AIRWORTHINESS DIRECTIVE

Boeing 747 Series Aeroplanes

AD/B747/278

Thrust Reversers

Thrust Reverser Sync-Lock Integrity Test

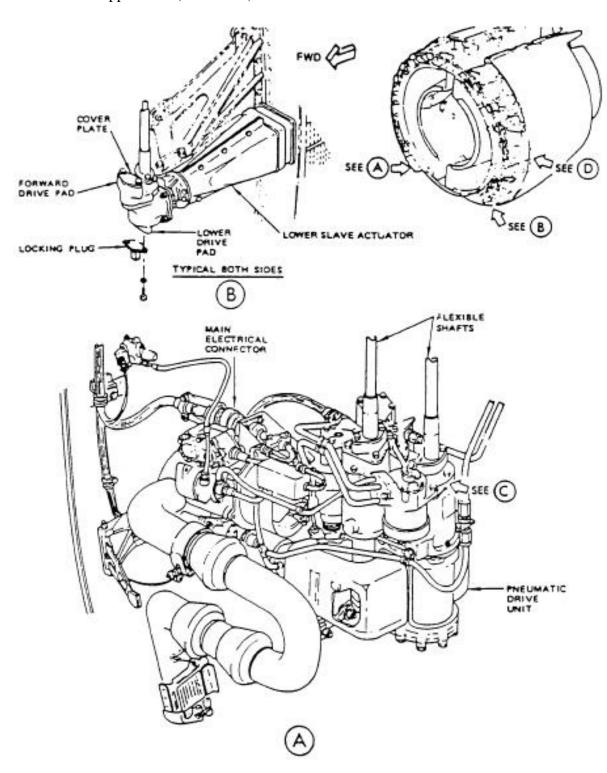
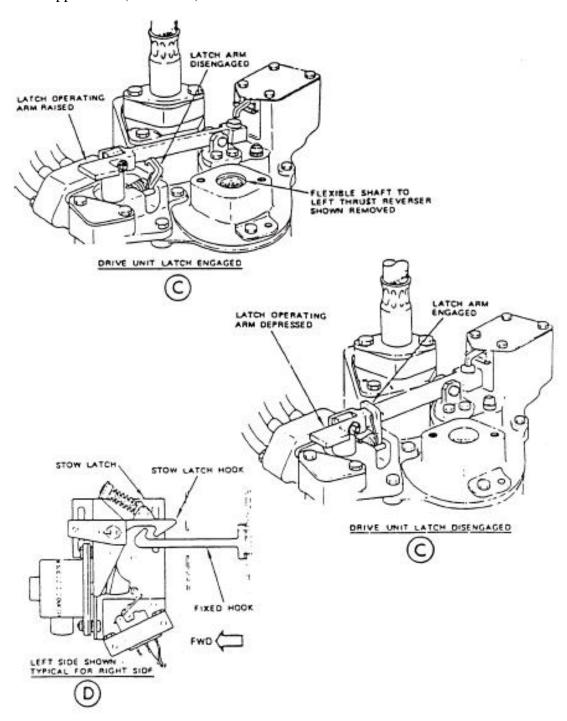
- 12. Perform a functional test to detect discrepancies of the additional locking system on each thrust reverser, in accordance with Appendix 1 (including Figures 1 and 2) of this Directive.

- 9. If sleeves move, replace the right-hand sync-lock.
- 10. Move left-hand sync-lock lever to the locked position.
- 11. Move right-hand sync-lock lever to the unlocked position.
- 12. Repeat step 8 above.

- 13. If sleeves move, replace the left-hand sync-lock.
- 14. Move left-hand sync-lock lever to the unlocked position.
- 15. Rotate actuator gearshaft to fully stow the sleeves.
- 16. When translating sleeves reach stowed position, check that stow latch hooks have engaged fixed hooks on both sides (detail D).
- 17. Depress latch operating arm and disengage latch arm (detail C); allow latch arm to raise.
- 18. After releasing arm, verify latch engagement by attempting to rotate feedback gear on drive unit using 1/4-inch square drive; gear shall not rotate in excess of 0.1 of a turn.

- 19. As applicable, install locking plug (with square section facing away from drive pad) or coverplate on actuator drive pad. Secure plug or plate with bolts tightened to 50-70 pound-inches.
- 20. Move both left- and right-hand sync-lock levers to the locked position.
- 21. Close fan cowl doors (Ref 71-11-02, Maintenance Practices).
- 22. Close T/R CONT & BLEED SYS circuit breaker.
- 23. Repeat the sync-lock integrity test on all remaining thrust reversers
